Reviewer #1

Reviewer #2

Reviewer #3

Figure 1. Correlation heatmaps for each of the analyzed reservoirs.

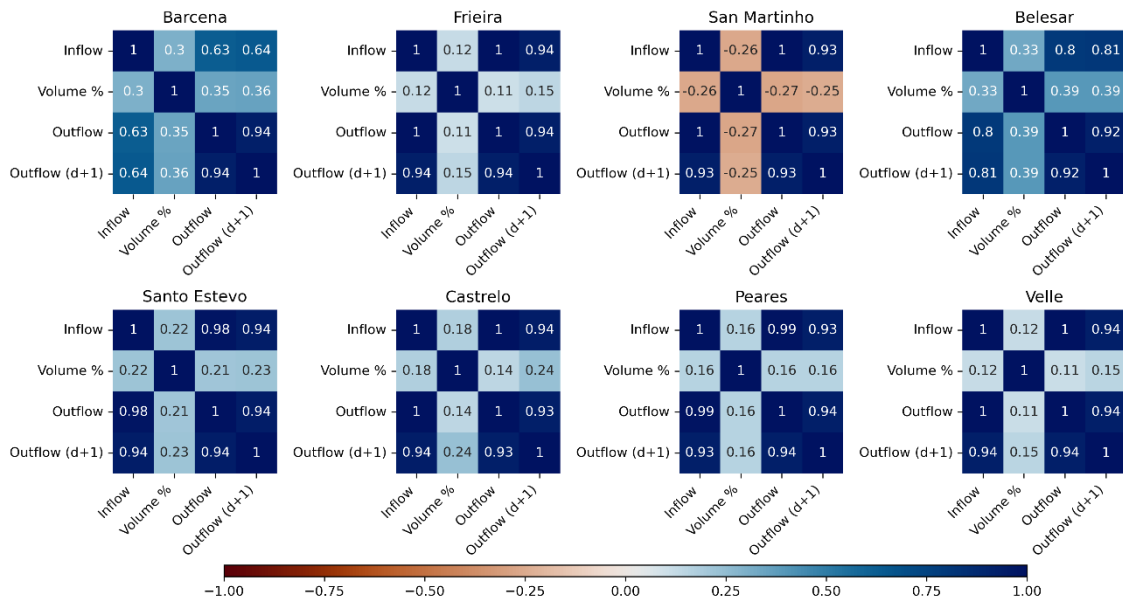
“For all the models, the inflow, outflow and volume percent values are used as input data to predict the outflow of the next day.”

Some exploratory plots would be useful (e.g., correlation plots)

A new figure was added with heatmaps of the correlation between variables for each of the reservoir:

Figure 2 shows the correlation between the variables involved for each of the analyzed reservoirs. It can be observed that there is a strong correlation between the inflow and the outflow variables. However, the two largest reservoirs analyzed (Barcena and Belesar) show a lower correlation between inflow and outflow, which is in concordance with their higher capacity and lower average occupation. The correlation between volume percent and the outflow is low all the cases but slightly higher on Barcena and Belesar.

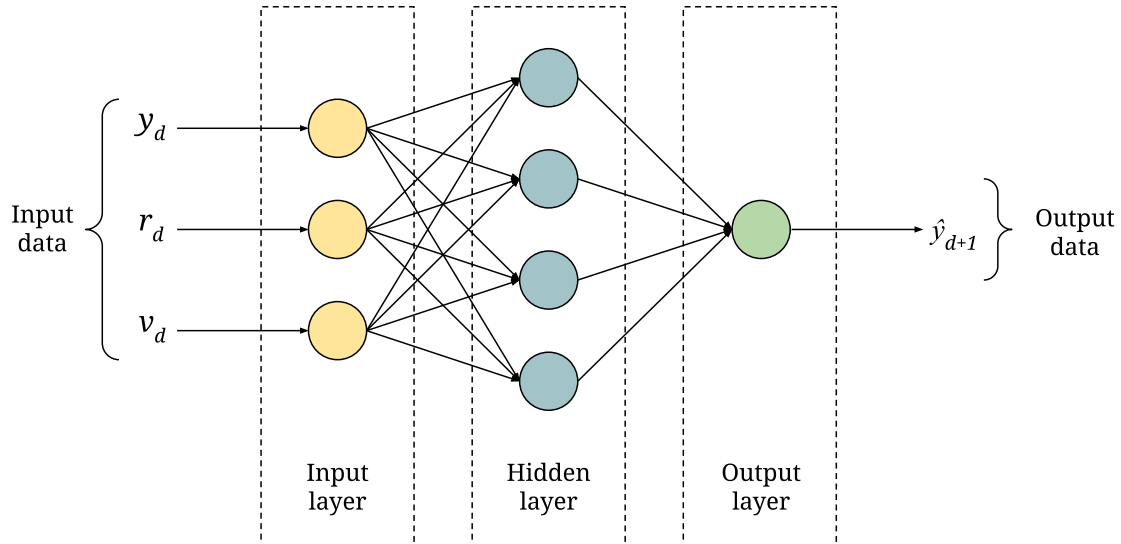
“In this sense, the number of neurons in the input layer is fixated by the number of variables (inflow, outflow and volume (%) at day d) that will be used to try to predict the desired variable (outflow for day d+1).”

Please, provide some reference to support this statement. According to Hastie et al [1], “Typically the number of hidden units is somewhere in the range of 5 to 100, with the number increasing with the number of inputs and number of training cases.” This means that there should be some relation between number of inputs and number of neurons, not that both quantities should be equal.

The sentence refers to the input layer of the ANN that depends on the number of input variables (see Figure 2 in the original manuscript). We have rewritten the paragraph to clarify this:

The figure of the architecture of a MLP was also modified using a variable nomenclature homogeneous with the rest of the paper:
